NAME	EE-4212V (7+4P)	MATERIAL	PM-9820	SCALE	1:1	ANGLE	±1°
DRAWING NO.	HX 4218A	PIN MATERIAL	CP WIRE	UNIT	m/m	REV.	03
东莞市华欣塑胶制品有限公司 DONGGUAN HUAXIN PLASTIC MANUFACTURING PRODUCTS CO., LTD. TEL: 0769-86388088 86388188 86388288 FAX: 0769-86388111 http://www.hxbobbin.com E-Mail: hxbobbin@vip.163.com	TOLERANCE OF PIN DIA ±0.05		— ⊕ —		UL REC. : 94V0		
	PIN TENSION LOAD 1.5 kg MIN		TOLERANCE: 0<L<4: ±0.1 4<L<16: ±0.2 16<L<63: ±0.3				
DRAWN & DRAFTED BY	LIN HUA JING	CHECKED & APPROVED BY		DATE:	AUG 22 2020

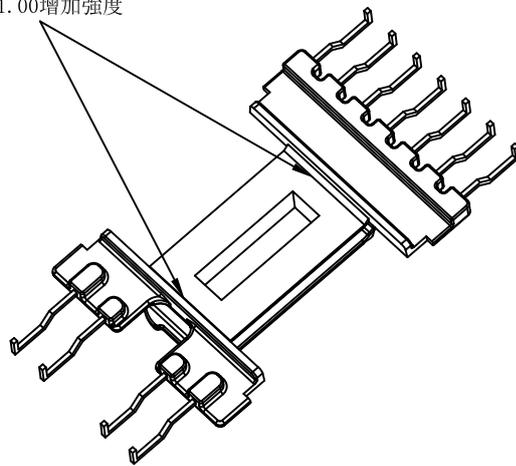
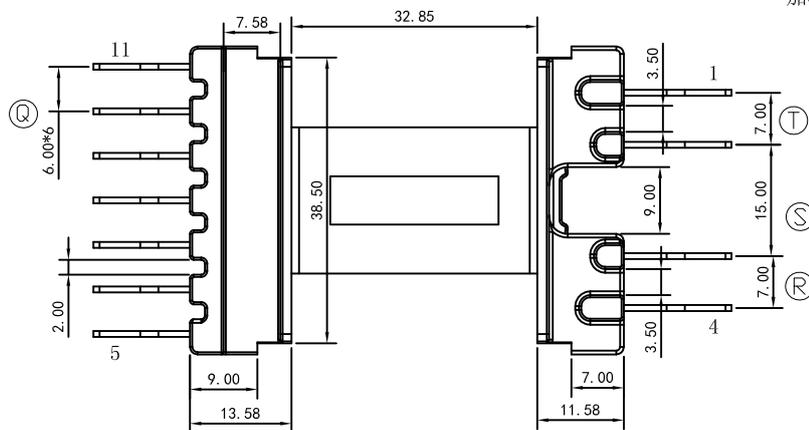
加C角1.00增加强度

REV.	REVISION RECORD	DATE	REV	REVISION RECORD	DATE
01	△ PIN挂板高度尺寸7.31改7.11	2020/09/25	03	△ F尺寸22.50±0.3改为22.50+0.3/-0.2	2022/02/15
02	△ P尺寸由3.30改为3.10; PIN台BASE中间胶位厚度1.30改为1.10	2020/11/05	04
